## Department of Planning, Zoning & Building

RE: November 12, 2014 LDRAB/LDRC Meeting

# LAND DEVELOPMENT REGULATION ADVISORY BOARD (LDRAB) LAND DEVELOPMENT REGULATION COMMISSION (LDRC)

# FENCES, WALLS AND HEDGES SUMMARY OF AMENDMENTS

Figure 5.B.1.A - Typical Example of Residential District Fence & and Wall Height

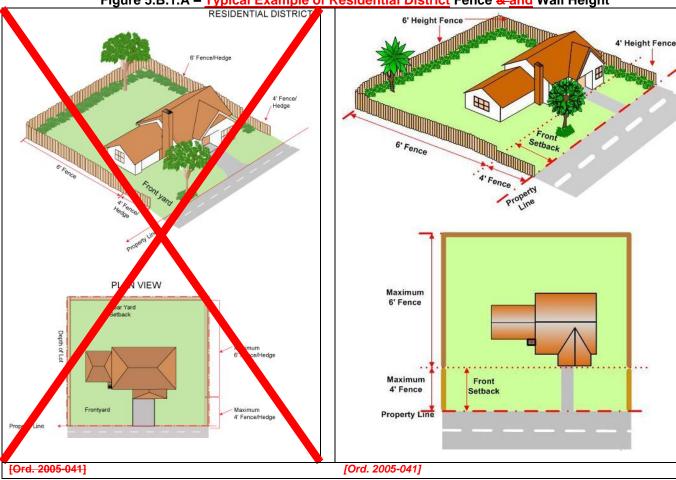
6. Update Figure 5.B.1.A title to reflect that this is a typical example for residential purposes.

7. Delete figure and replace with new figure which deletes incorrect reference to "front yard", as the code provisions states setbacks not yard, and hedges which is illustrated in 7.D.3.B, Residential Hedge Height. Note that yard is defined as the area in-between the property line and the principal structure, which is often larger than the minimum required setback.

Figure 5.B.1.A - Residential District Grade Changes **Examples of Wall in the Side or Rear Setbacks**

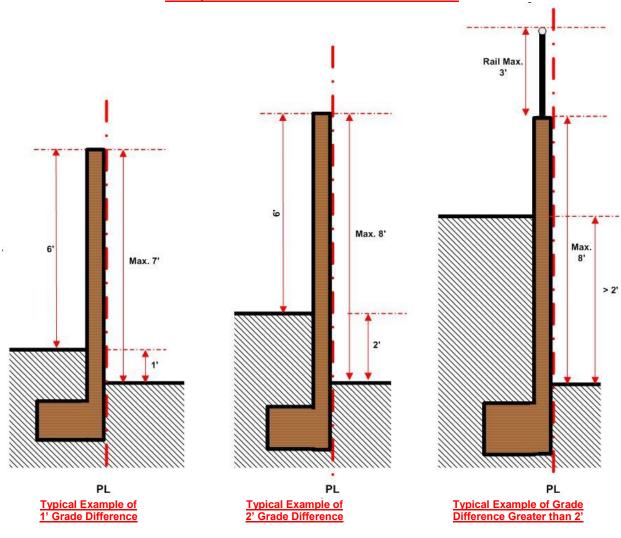
- 9. Correct figure to reflect height of attachments.
- 10. Delete figure and replace with new figure, which deletes entrance wall sign, which is addressed in Art. and Figure 8.G.2.C Entrance Signs, and corrects illustration of how height of attachment is measured.

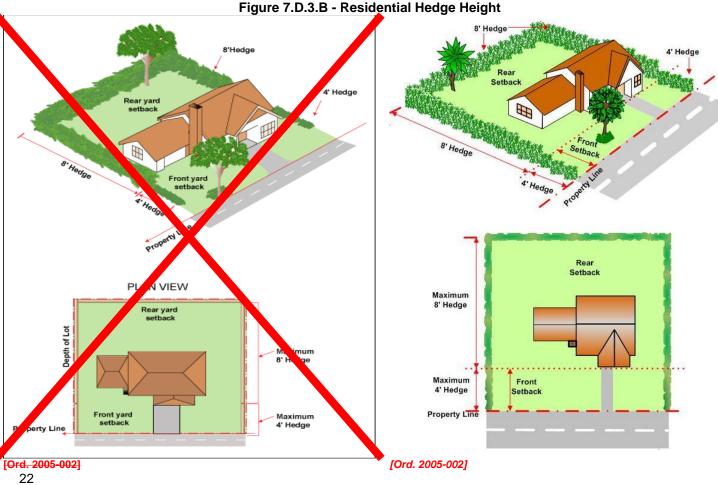
- Relocate Figure 7.D.3.B, Residential Hedge Height to immediately below items B.1 and B.2 to improve ease of use. Illustration still applies to Art. 7.D.3.B.3, Shrubs, but is predominantly used for the above requirements.
- Delete existing Figure and replace with new figure that deletes reference to "yard."
